SUBJECT: Resolution 2014-02, Site Plan Amendment for Hilton Hotel, 4711
Gulf of Mexico Drive

SUBJECT: LONGBOAT KEY HILTON HOTEL – SITE PLAN AMENDMENT

SUBJECT: Longboat Key Hilton Hotel Site Plan Amendment

**Longboat Key Hilton Hotel
Site Plan Amendment
Resolution 2014-02**

Parking Layout

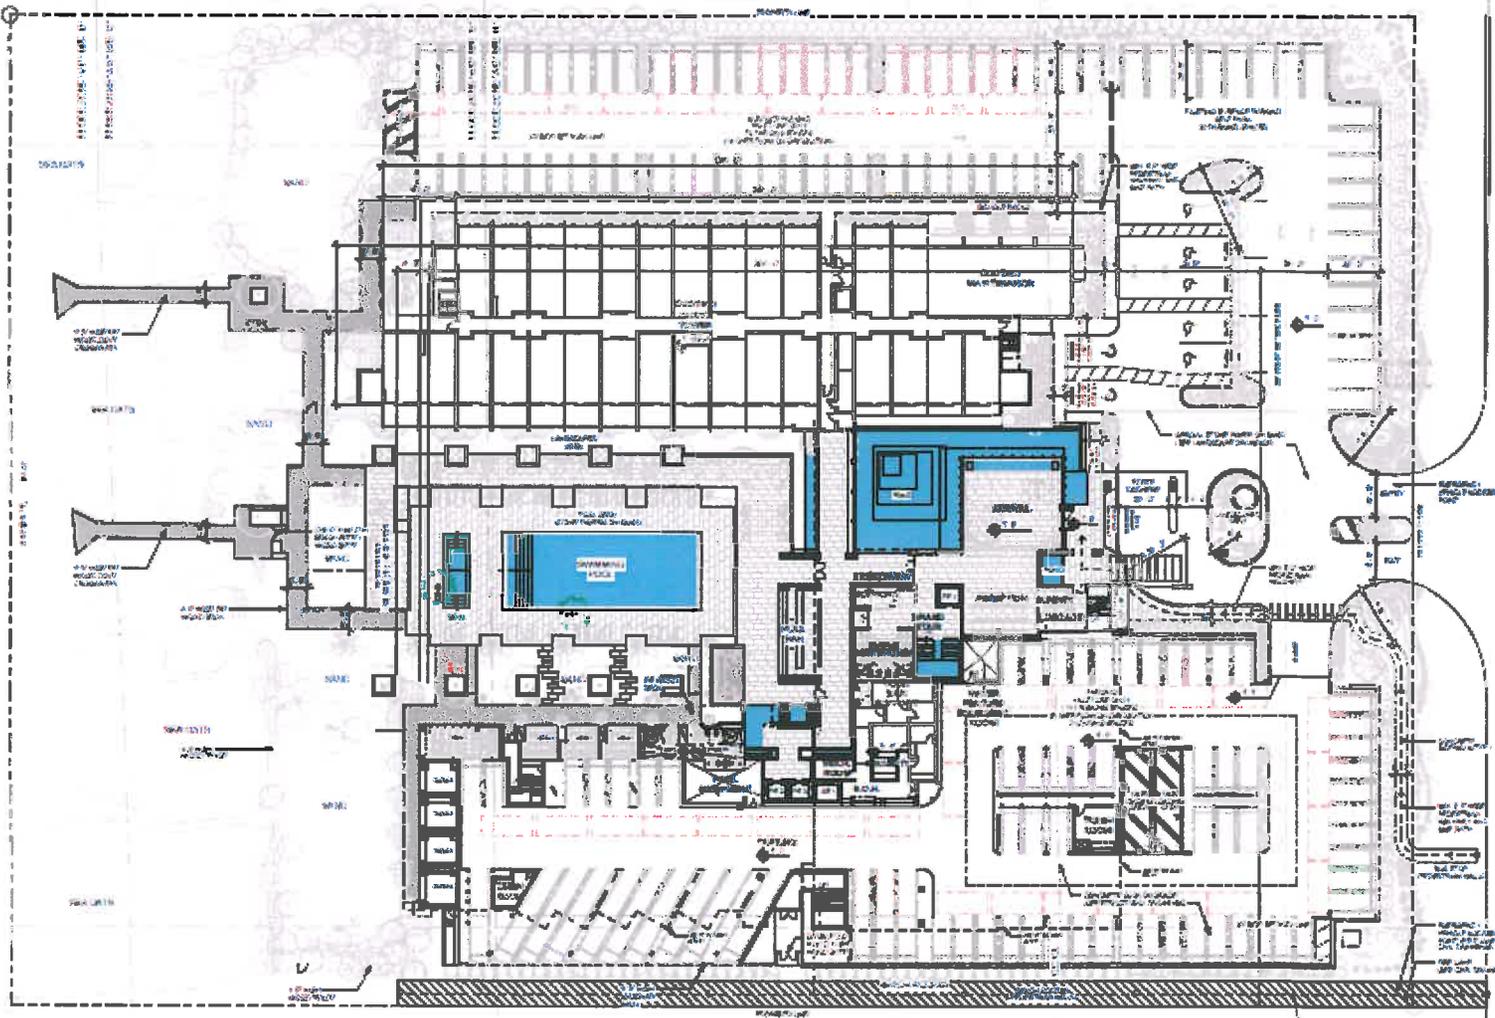
Off-Street Parking: The applicant is proposing to provide 215 parking spaces on the site, with 187 spaces reserved for valet and/or staff parking. The Code requires 214

Landscaping Plan

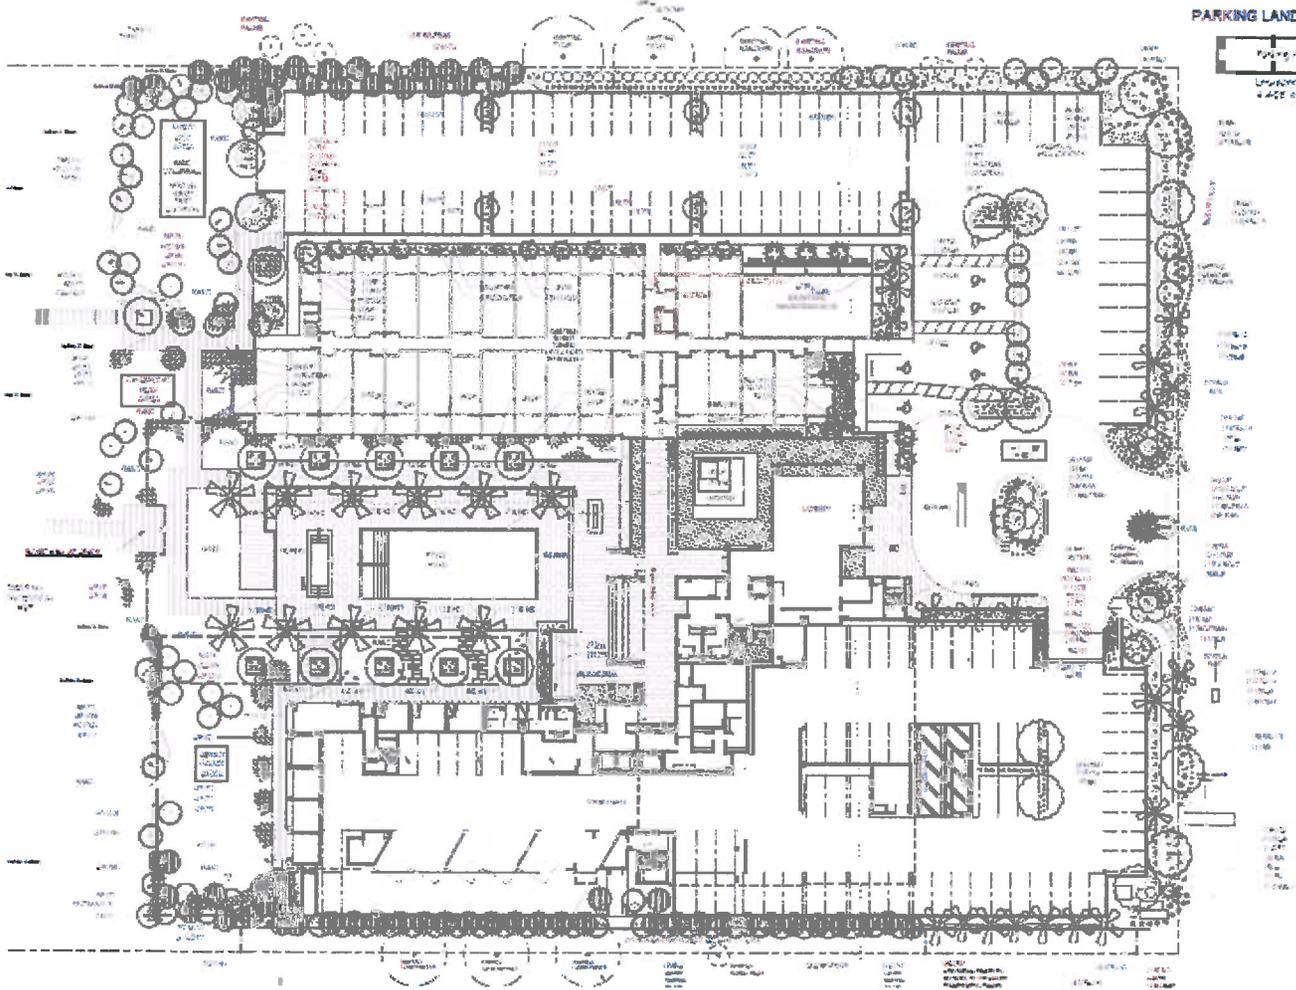
Landscaping: The proposed buffering of the site along Gulf of Mexico Drive would be an increased from the existing buffer. The applicant plans to preserve the mature native trees located in the existing buffer areas and will plant additional vegetation that does not currently exist in the lower canopy. The landscape plan incorporates a mix of drought tolerant, salt tolerant, native vegetation with extensive ground cover. The applicant also proposes to provide substantial landscaping along the side property lines, although this is not required by the code. Most of the existing trees will be preserved or relocated on the site.

Larry Washmuth, landscape architect for the project, was introduced. Mr. Symanski noted the Urban Land Institute (ULI) representatives recommended a planting scheme for along Gulf of Mexico Drive. He asked if the Town developed the plan in a timely fashion would the Hilton Hotel be flexible in adjusting their plan to take that into account. Mr. Patterson responded the applicant would take that into consideration.

- 16) Existing mature trees shall be preserved to the greatest extent possible in accordance with the submitted tree plan (Sheet C16), dated October 22, 2013, and received by the Town on October 23, 2013.

- 17) The approved landscaping, as presented to the Town on the plans, dated July 28, 2012, (revised October 18, 2013) and received by the Town on October 23, 2013, shall be maintained and replaced if necessary at an equivalent maturity level. The cost of maintenance and replacement shall be the responsibility of the property owner.
